Access Compliance Report

Public Rights-of-Way

(Curb Ramps)

Intersection ID: N/A	Main Street: CRESSWIND BV	Cross Street: TREESDALE LN	Location: S
ADA ID: CF50AC0041EB	Ramp Type: Perp	Initial Pass/Fail: Fail	Overall Compliance: No
Codes/Mitigation Info/Possible Solution		Field Measurements/Component Compliance	
Severity Score: 13.75

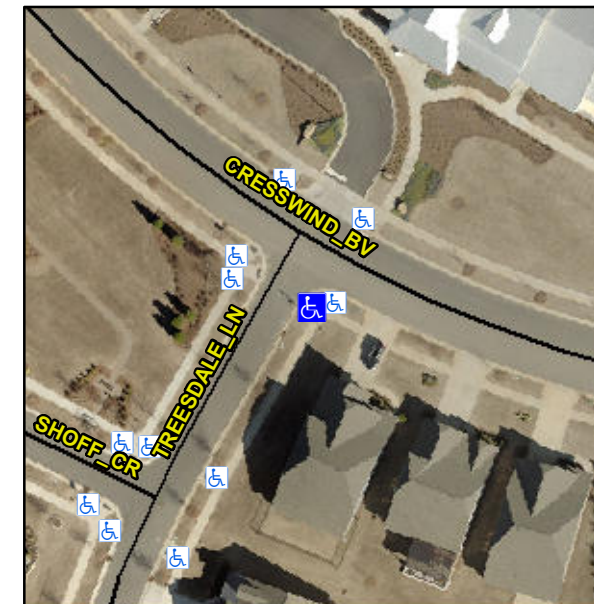
R304.2.2, R304.5.3

Compliance	Description	Data	Compliance	Description	Data
N/A	Ramp Length (in)	100.0	No	Ramp Slope (%)	9.1
Yes	Ramp Width (in)	48.0	No	Ramp XSlope (%)	4.5
N/A	Flare Type LT	N/A	N/A	Flare Type RT	N/A
N/A	Flare Slope LT (%)	N/A	N/A	Flare Slope RT (%)	N/A
N/A	Flare Traversable LT?	No	N/A	Flare Traversable RT?	No
N/A	Landing Length (in)	N/A	N/A	DWS Provided?	N/A
N/A	Landing Width (in)	N/A	N/A	DWS Contrast?	N/A
N/A	Landing Slope (%)	N/A	N/A	DWS Length (in)	N/A
N/A	Landing X Slope (%)	N/A	N/A	DWS Full Width?	N/A
N/A	Landing Curb? (Y/N)	N/A	N/A	DWS Offset (in)	N/A
N/A	Shared Landing?	N/A			
N/A	Gutter Ponding?	N/A	N/A	Gutter Slope (%)	N/A
N/A	Gutter Lip Ht (in)	1.0	N/A	Gutter X Slope (%)	N/A
N/A	Painted X Walk1?	No	N/A	Painted X Walk2?	N/A
	X Walk 1 Direction	To NW		X Walk 2 Direction	N/A
N/A	X Walk 1 Width (in)	N/A	N/A	X Walk 2 Width (in)	N/A
	X Walk 1 Slope (%)	2.7		X Walk 2 Slope (%)	N/A
	X Walk 1 X Slope (%)	2.1		X Walk 2 X Slope (%)	N/A

Remove & Replace Entire Ramp.
